Sram battery backup

I don't have an option here in my country , **No non-volatile** sram and i need it for my project . i designed a circuit for that and need anyone's opinion if it's ok or need a correction .

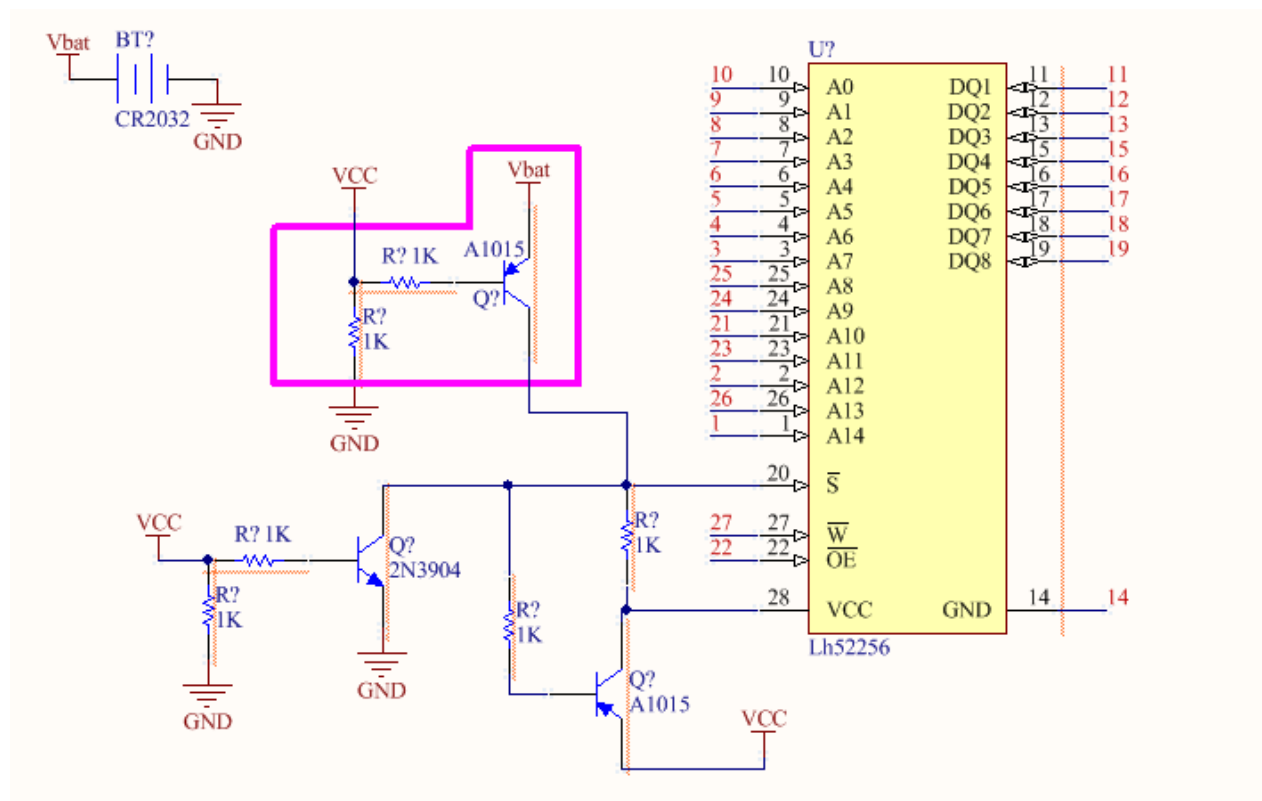
How much memory do you need? Some RTCs like DS1307 have some spare bytes that are battery backed. – [filo](#) Apr 4 '18 at 5:22

There are battery back-up IC's for sram that use MOSFET's so no Vdrop or extra current drain. – [user105652](#) Apr 4 '18 at 5:33

Look into the Maxim Max703/704. They are designed for lithium coin cells. – [user105652](#) Apr 4 '18 at 5:37

2 Use double asterisk (**) around a word you want in bold. I would always recommend a MOSFET over a bjt, just because you can bias them with 1 or 2 megohm resistors. Very little current is wasted. – [user105652](#) Apr 4 '18 at 5:46

I see at least three problems:

- The two 1 k Ω at the battery transistor will draw too much current when VCC is out. 40 k Ω each seems more appropriate to me. $(2.2\text{V} / (1\mu\text{A} / 25)) \approx 88\text{ k}\Omega$; 40 k Ω should be good enough.

- When the battery is half used its voltage will be below the minimum data retention voltage, plus you will have a (small) voltage drop at the transistor. This may or may not work, or, worst, it may work when you test it and stop working at a later time.

- The 2N3904 will not cut until VCC is below 0.7~0.8 V. If VCC goes down slowly (electrolytic capacitors, ...) there will be a time during which both this transistor and the one feeding current from the battery will be active. In this situation the third transistor, the bottom one, will probably work in reverse and feed current from the battery to VCC (VCC is now 1 or 2 volts *below* Vbat). This will drain the battery through the 1 k Ω . In the worst scenario the leak will keep VCC above .7 V and, because it will never stop, it will drain the battery in a few days.

I'd suggest changing the two resistors at the base of the 2N3904 to a divisor that will cut it somewhere between 3 and 4 volts at VCC, possibly adding a third resistor from the emitter of the bottom transistor to introduce a Smith Trigger effect and avoid any possibility of oscillations during the transition.

this is my new design

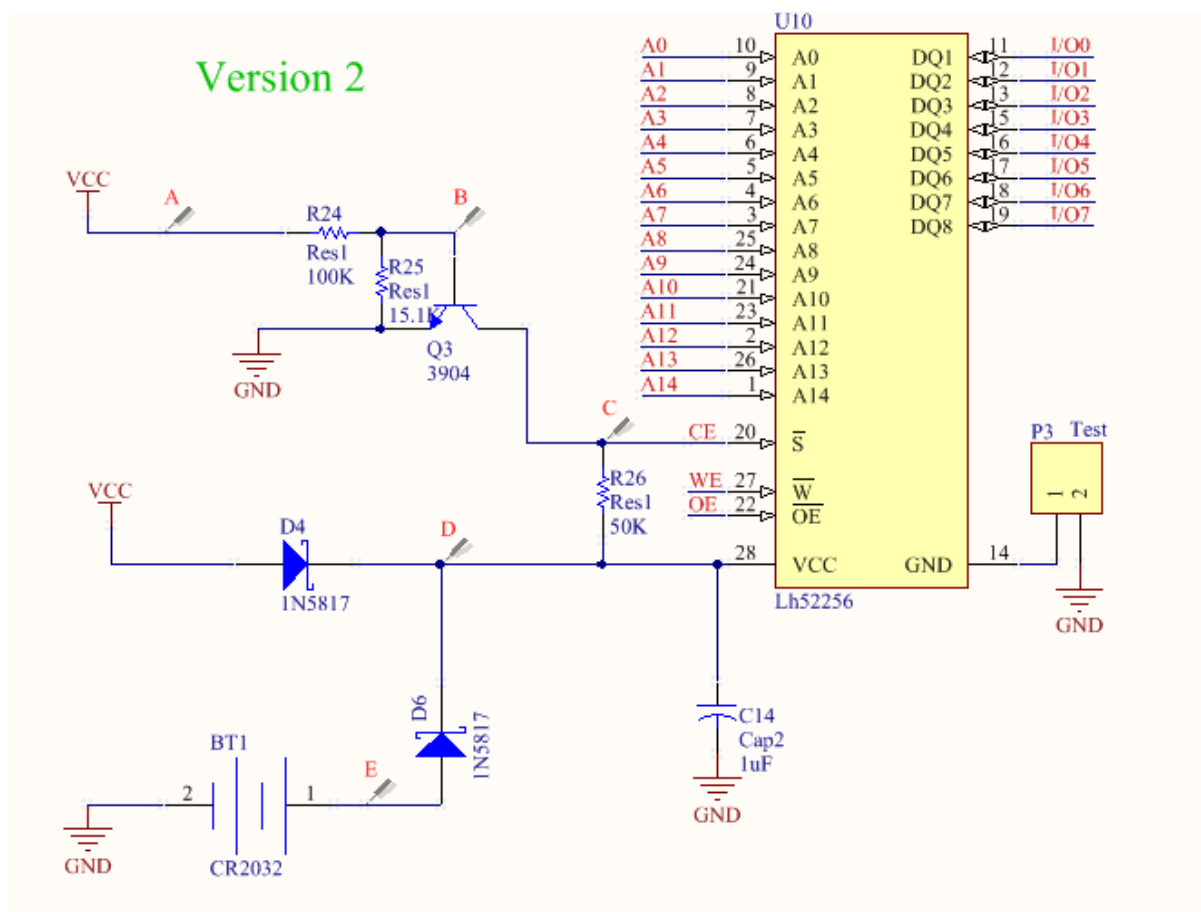
Isn't R27 too high? 330K? At 1uA it will be a minimum 0.3V voltage drop on it. Not to mention the noise sensitivity of such a high impedance point. – Dorian Apr 18 '18 at 12:03

I think you also misread the datasheet, the max standby current is 50uA and 6 typical, not 1uA. 1uA is the input leakage current that is a different thing. Still, this solution is good if you change the value of R27 to a much lower value. Or just connect D6 straight to D point. This will help in case that RAM leaves the suspend state while on battery for a short time. – [Dorian](#) Apr 18 '18 at 12:12

2.7 across R27? With a 3.4V fully charged CR2032 and the diode will leave 0.5 for VDD? Can you post a link to the datasheet you use? – [Dorian](#) Apr 20 '18 at 7:28

First, I would avoid any not needed high impedance point. You want your data to survive for 3 years, anything can happen, a voltage spike, a GSM phone or a piezo lighter used near your board. I would use lower values for R25..R27. None of them have nothing to do with the power consumption but higher values can lead to a higher noise sensitivity.

In fact you should drop R27 because the circuit should be resilient to transitory out of the standby events that might happen on power off/on or due to unwanted voltage spikes.

The datasheet I found states maximum 1 uA for 25 degrees Celsius, 3 for 40 and 15 over the temperature range at 3v Vddr, I wouldn't worry too much about that, you won't keep your board for three years at 80C. 5uA overall would be fine for an approximation. Rather a temporary high current (due to a high temperature) combined with the high value of R27 can lead to VDD to drop under the retention voltage.

I would use R24 = 100k, R25 = 15.1k, R26 = 20k and R27 = 0
